## DEVELOPMENT REVIEW COMMITTEE

**1. Bello Corner (Previously Santaquin Ostler) Subdivision Plan**

**2. Wasatch Steel Site Plan**

# BELLO CORNER SANTAQUIN, UTAH

### BELLO CORNER - PLAT "A"

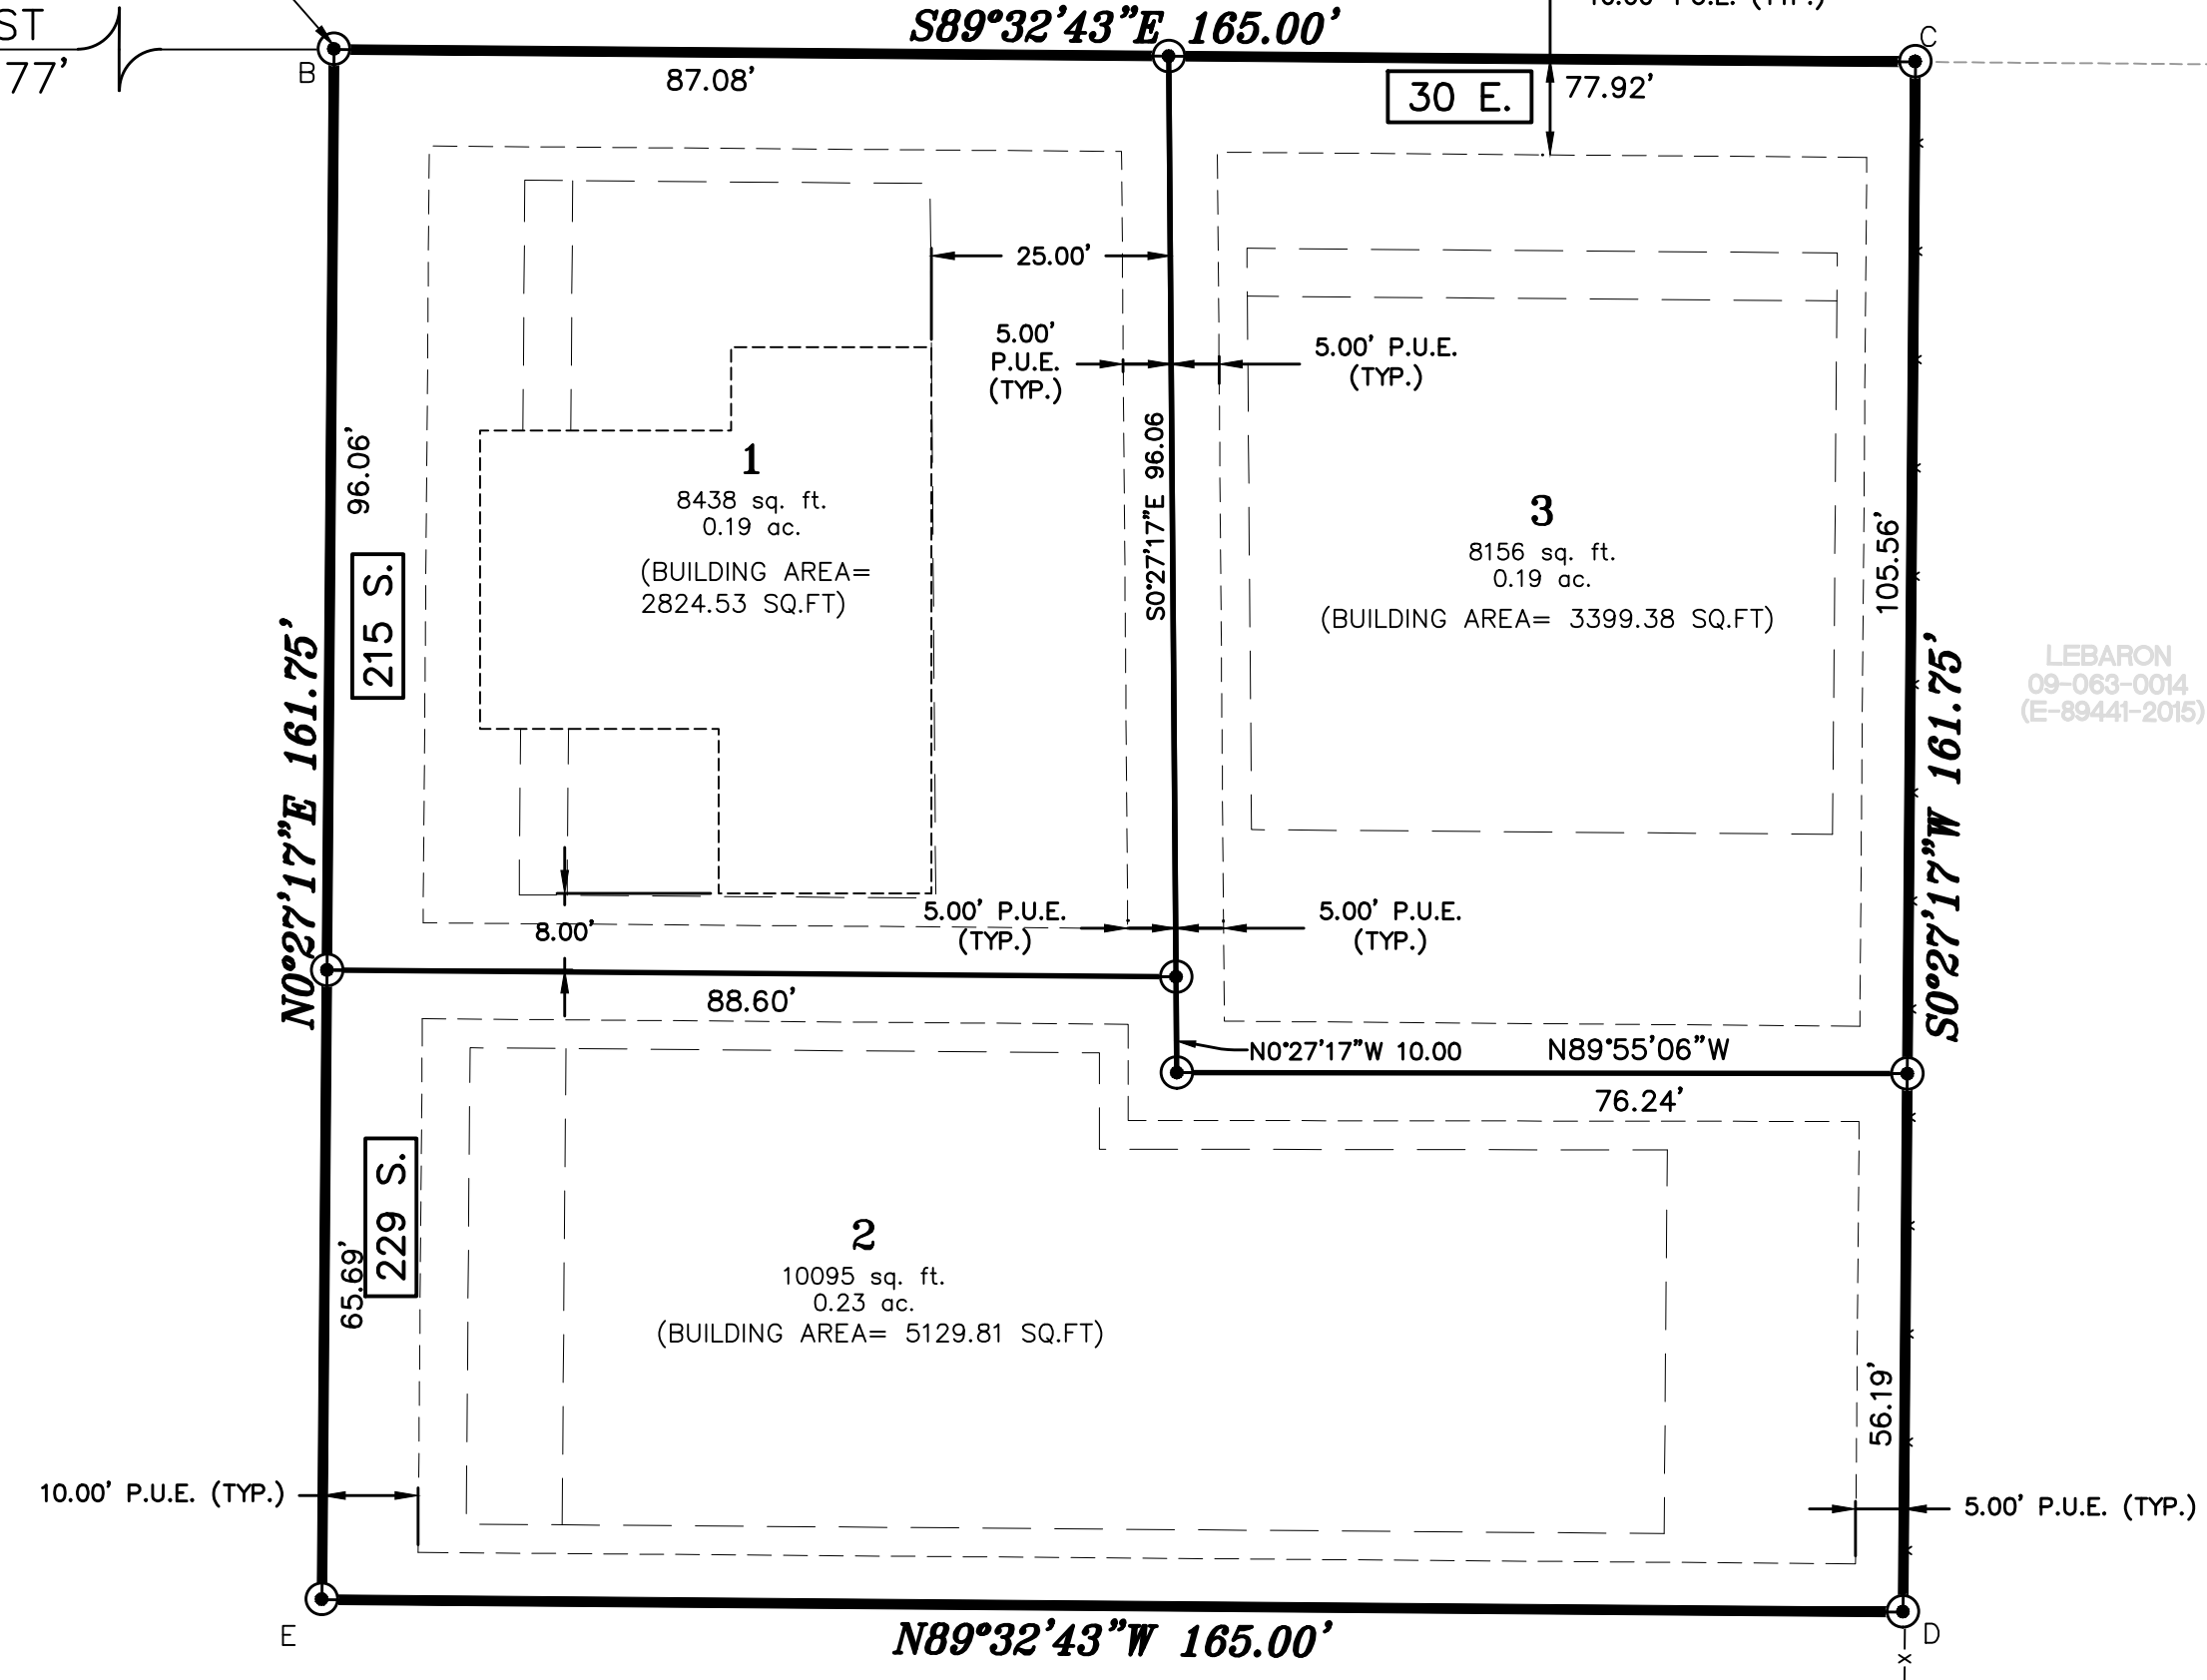
Assistant City Manager Bond discussed the zoning requirements for the lots, pointing out that the lots are required to be at least 8,000 square feet. As such, lot 2 does not meet City Code and will need to be adjusted. Assistant Manager Bond suggested that lot 3 has sufficient square footage to provide the needed additional square footage in lot 2 with some minor property line adjustments. Assistant City Manager Bond explained that the applicant is requesting infill reduction which will allow the reduction of the frontage requirements for Lot 2 & 3. The infill reduction will need to be approved by the Planning Commission He added that Lot 1 will still need to meet the appropriate setbacks as required by City Code.

Planner Harris indicated that the County Surveyors Office requires a Public Land Survey System (PLSS) Certificate be submitted to the City. He also pointed out notes that need to be added to the plans. Senior Planner Harris discussed with the applicant the possible deferral agreement. If the deferral agreement is approved by the City Council, all street improvements and the storm drain report will not be required.

EIT Megan Wilson pointed out where the existing PI and water lines are located on the property. She added that permission from Summit Creek Irrigation Company is required before any work interferes with the culvert flowline.

Lastly, Planner Harris updated the acceptance and approval signature blocks on the plat as well as agricultural notations. He also requested that the applicant change the name of the subdivision as an "Ostler" subdivision already is under construction in the City. The subdivision name change will need to be submitted prior to the deferral agreement being submitted to the City Council for review.
